RE: **10512 Redbud Residence**
10512 Redbud NW
Pad Certification Dated: 4/8/18
Grading Plan Stamp Date: 1/15/18
Hydrology File: A12D027

Based on the submittal received 4/9/18, the Pad Certification cannot be approved until the following are corrected:

ENGINEER'S SEAL 1/15/18 DAVID SOULE P.E. #14522	REDBUD RESIDENCE	DRAWN BY WCVJ
	GRADING AND DRAINAGE PLAN	DATE 1-11-18
	 1606 CENTRAL AVENUE SE SUITE 201 ALBUQUERQUE, NM 87106 (505) 872-0999	21752-LAYOUT-6-15-17 SHEET # — JOB # 21752

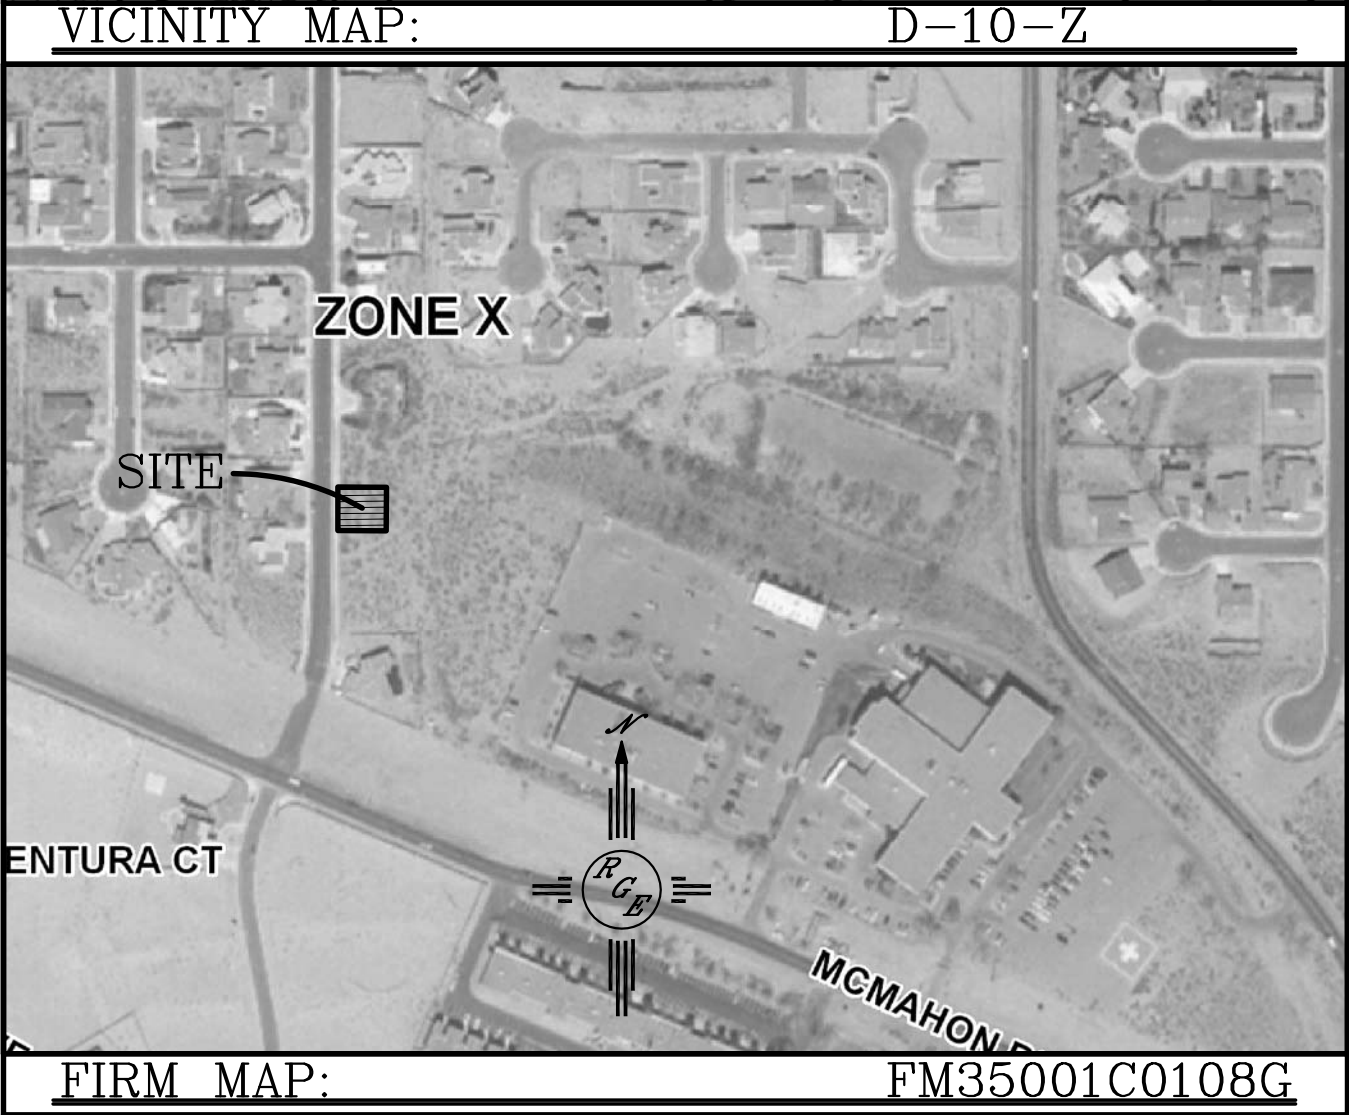
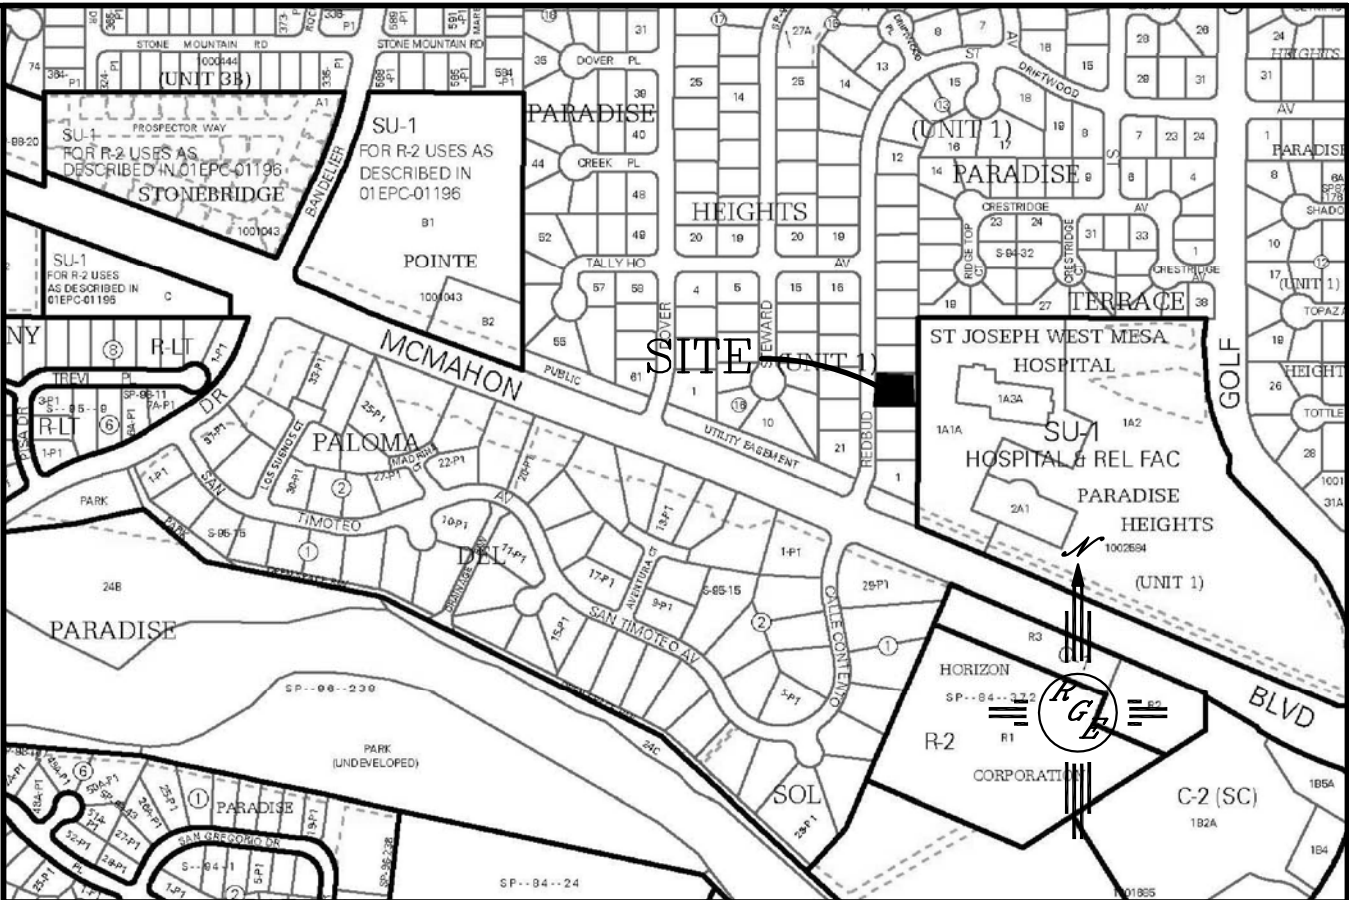
1. Provide written permission from the adjoining landowner to the south (Lot 3) for the grading on their property. This permission will need to include: permission to grade, affirmation that the undersigned is the owner of Lot 3, and owner signature.
2. A revised grading plan, showing the additional grading is required.
3. Include a reseeding and site stabilization specification for the additional graded areas that won't be developed with the subject lot. Reseeding and stabilization will be checked at C.O.
